Re: Preliminary Plat for Lavitt Manor II—Two Lot Subdivision: 7525 N. Ironwood Drive

Based solely on the current Town of Paradise Valley Code and Storm Drainage Design Manual, the revised documents provided to this Commission by the Applicant for the proposed Lavitt Manor II subdivision have deficiencies requiring the Preliminary Plat be rejected:

PAVING GRADING DRAINAGE LAVITT MANOR II

5. PUBLIC HEARINGS 19-302 CONSIDERATION OF PRELIMINARY PLAT

DRAWING NO:
C20f3

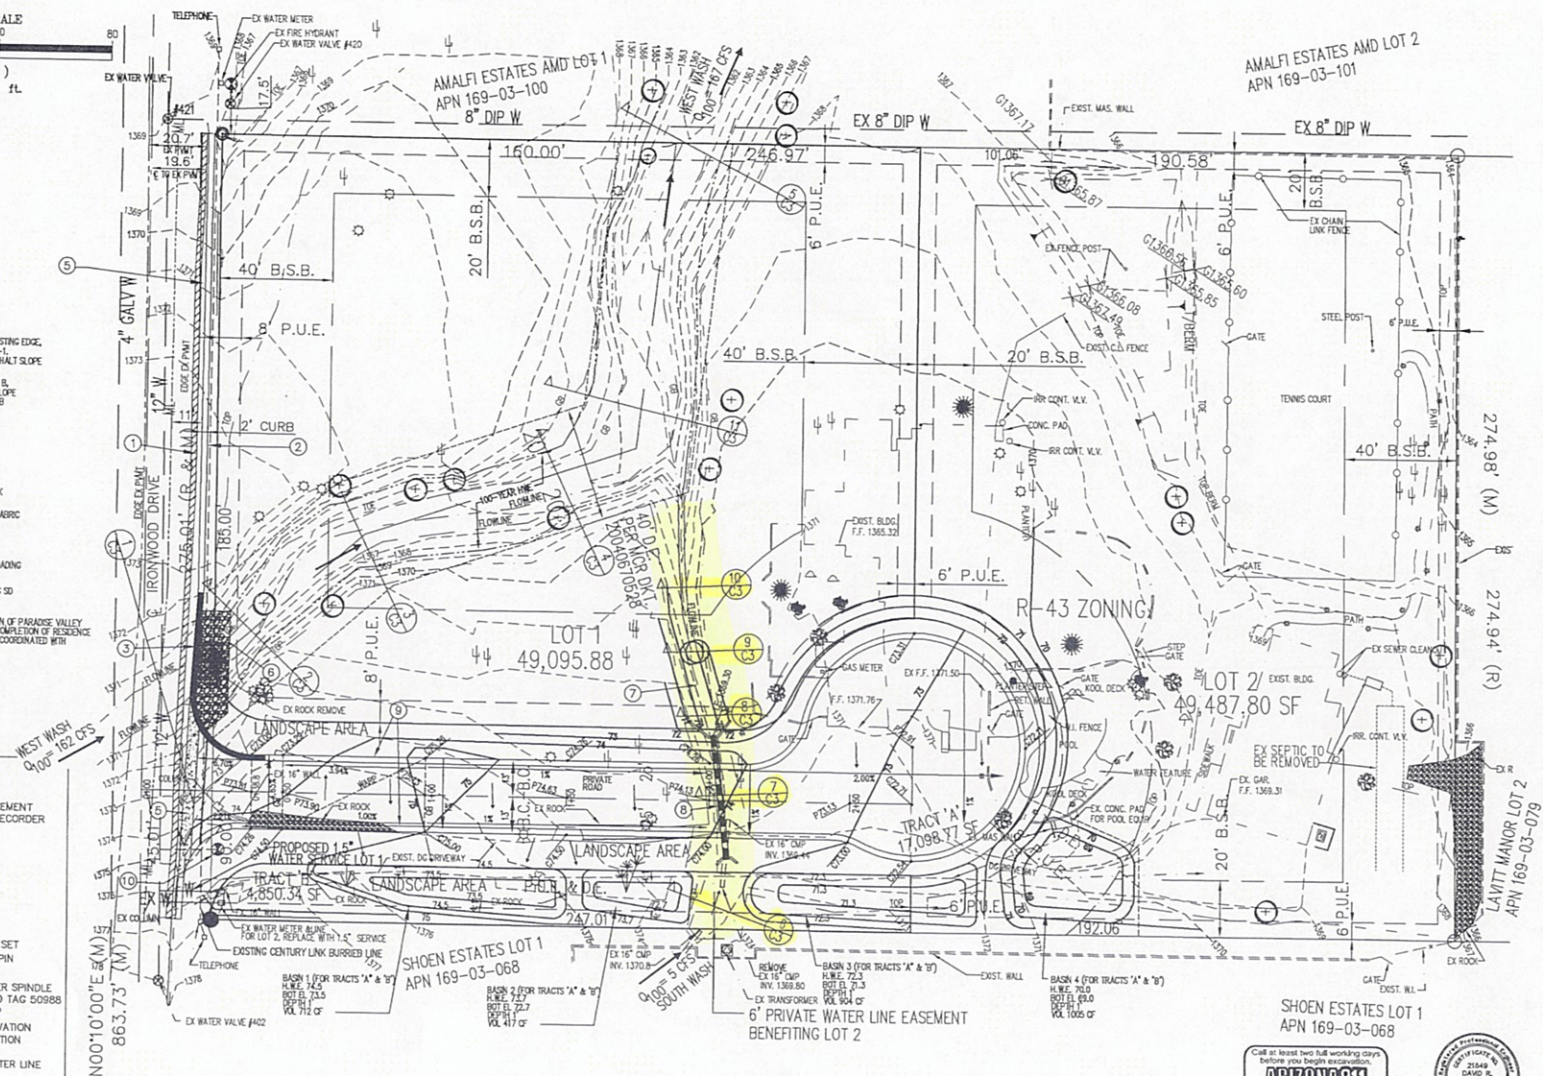
1. Impossible to track lines of “TOB” on the plat.
2. Does not show required 5 foot “landscape buffer” that is required to be “perpendicular from the top of the bank.”
3. Cannot tell whether proposed easement conforms with the Storm Drainage Manual

- Paving Grading Drainage Exhibit showing:
 - Topography showing top of the bank of each side of the southern wash;
 - Separate line showing 5 foot landscape buffer on each side of the top of the bank;
 - Separate line showing proposed easement that reflects all points of the new easement are outside the 5 foot landscape buffer.
 - Revised Drainage Easement and Drainage Easement Agreement being provided to the Town of Paradise Valley reflecting southern Natural Wash inclusion.

- Revised Preliminary Plat reflecting all of the above.
- Recommend Preliminary Plat reflect the actual buildable square footage in northwest corner of Lot1.
